Re: Shiflett Family Management

IDWR is reviewing the transfer proposal for Shiflett. We cannot approve the transfer as currently configured.

Lost Peaks Ranch
Groundwater Wells

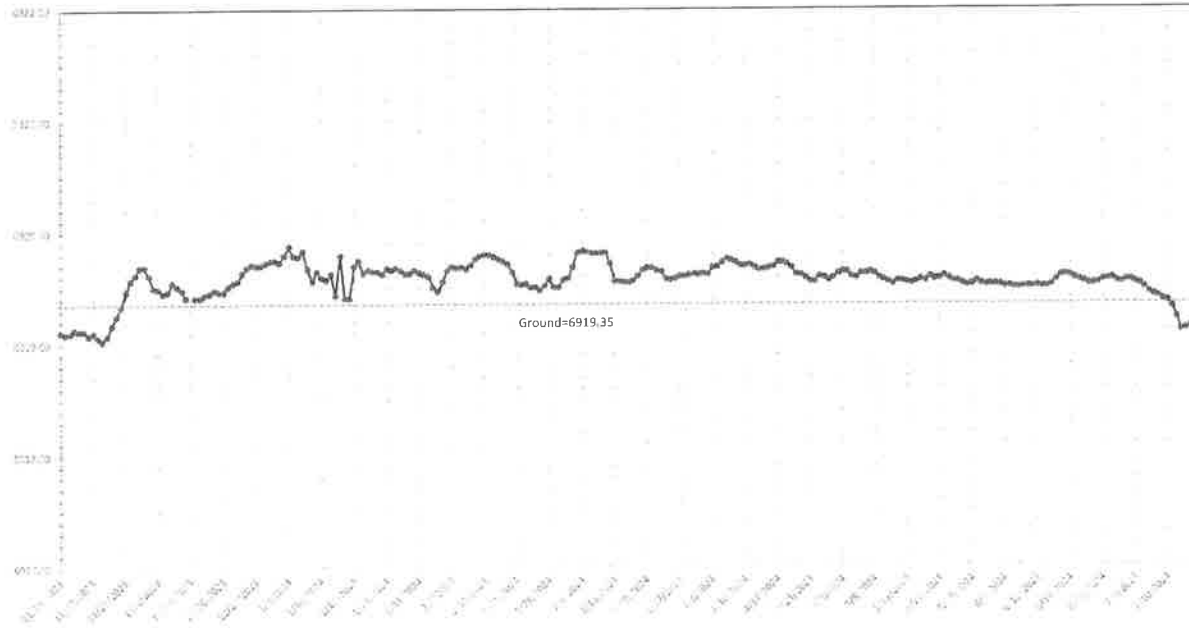
- the acres being converted for evaporation only authorize water to be stored for evaporation loss. Not enough water is being authorized to allow for first-time fill or for seepage.
- I understand that the mitigation plan is to dry up 21 acres one time. Nothing indicates that the pond will stay full through the winter, meaning multiple first time fills will be necessary.

"We monitored groundwater levels in the proposed pond sites from November 2023 to July 2024 and used that information for design of the pond levels. See attached plots of the groundwater levels, well 2 was in the footprint of the upper pond (design water level 6925) and well 1 was in the lower pond (design water level of 6919). Very steady, shallow groundwater and above the design water levels so seepage out should be nil."

Based on this study we expect that we will only need first-time fill once as the pond won't dry every year and that seepage from the pond will be so small as to be negligible.
